Technical Notice

Product Name: ICE-ULT3 products.

This notice is to inform you of changes to the
Computer on Module: ICE-ULT3 series

PN: 19100-000221-00-RS	PN: 19100-000235-00-RS

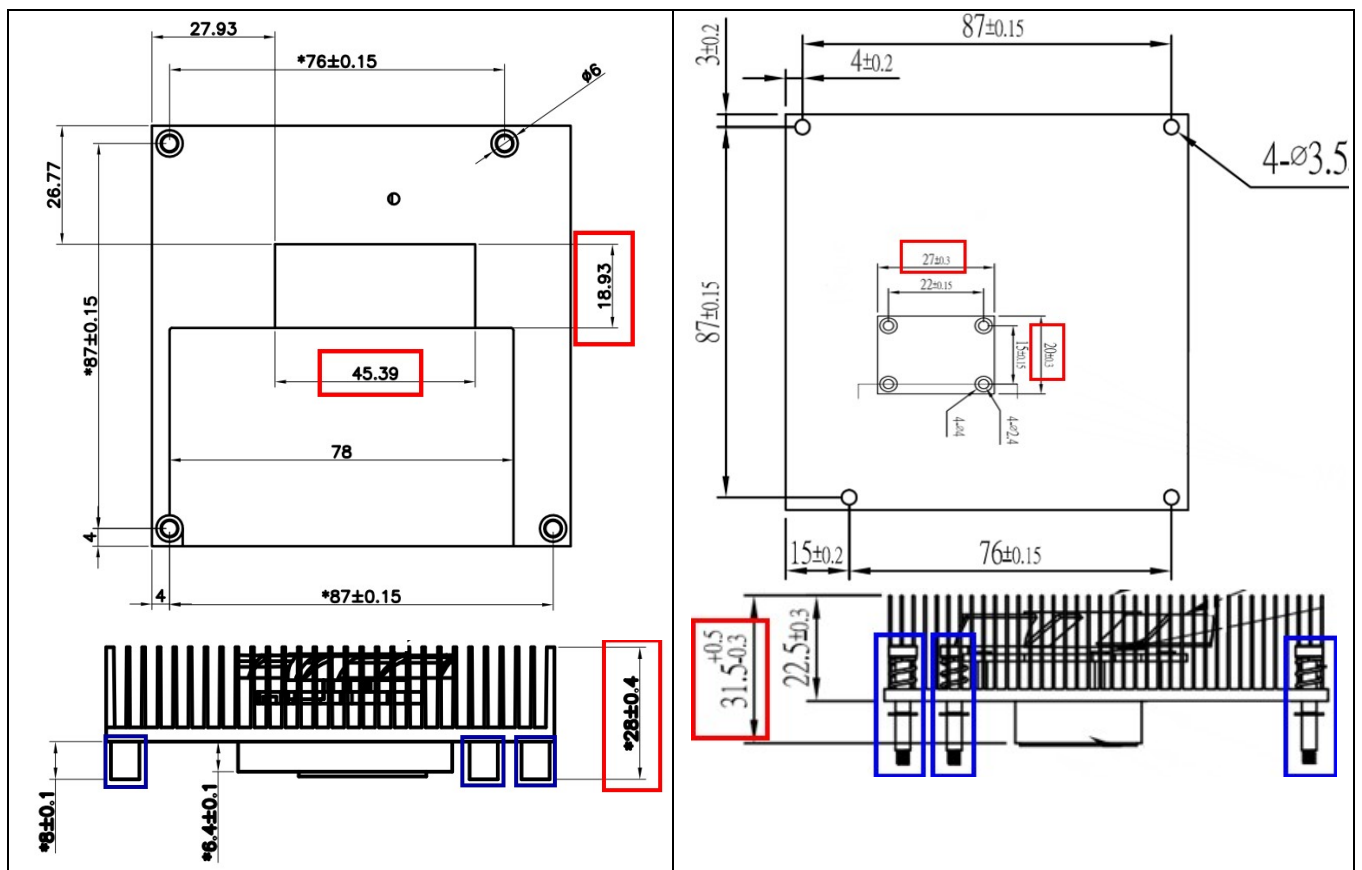
The heat sink of ICE-ULT3 is EOL. IEI will start transitioning the heat sink of the related products from 19100-000221-00-RS to 19100-000235-00-RS.

Change the heat sink from 19100-000221-00-RS to 19100-000235-00-RS.
